UNITED STATES PATENT AND TRADEMARK OFFICE

APPLICATION NO.	FILING DATE	FIRST NAMED INVENTOR	ATTORNEY DOCKET NO.	CONFIRMATION NO.
10/733,873	12/10/2003	Gilles Benoit	13445-030001 / L7 (MIT	8066
26161	7590	03/09/2006	10	
FISH & RICHARDSON PC P.O. BOX 1022 MINNEAPOLIS, MN 55440-1022			EXAMINER ROJAS, OMAR R	
			ART UNIT	PAPER NUMBER
			2874

Office Action Summary

DETAILED ACTION

**FIG_1****FIG_2**

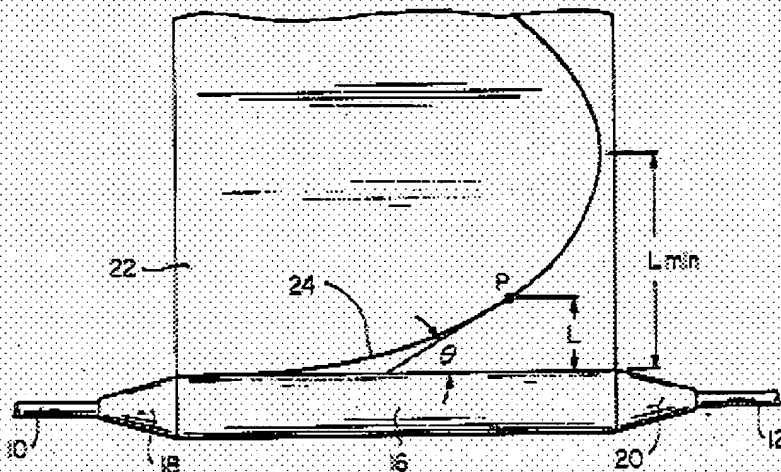
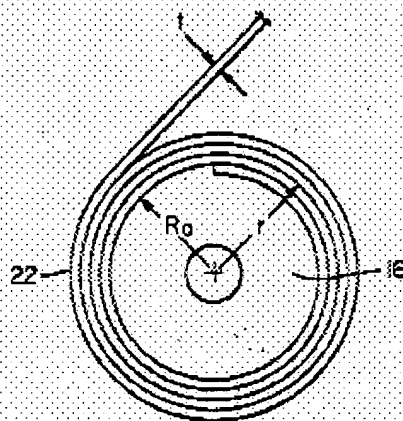
In re claim 26, Fentress discloses an article comprising a fiber waveguide (Figures 1-3) comprising alternating layers (22, 24) of different materials surrounding a core 16 extending along a waveguide axis, wherein the alternating layers (22, 24) define a spiral structure (col. 3, lines 3-10). Figures 1 and 2 of Fentress are reproduced below.

In re claim 27, wherein the spiral structure comprises a multilayer structure comprising at least

two layers (22, 24) of the different materials encircling the core multiple times (see also col. 3, line 54 to col. 4, line 20).

In re claim 32, Fentress suggests that an innermost layer of the one of the alternating layers 22 has a thinner portion than that of subsequent layers of the same material (see col. 3, lines 57-59).

In re claim 36, the core 16 may be hollow (col. 4, ll. 37-39).

In re claims 49-51, 57, and 61 the previous remarks concerning claim 26, 32, and 36 are incorporated herein. Fentress further teaches that the alternating layer 22 comprises polymeric foam and alternating layer 24 may comprise glass (col. 1, ll. 20-25). Thus, Fentress anticipates each and every limitation of claims 49-51, 57, and 61 as well.
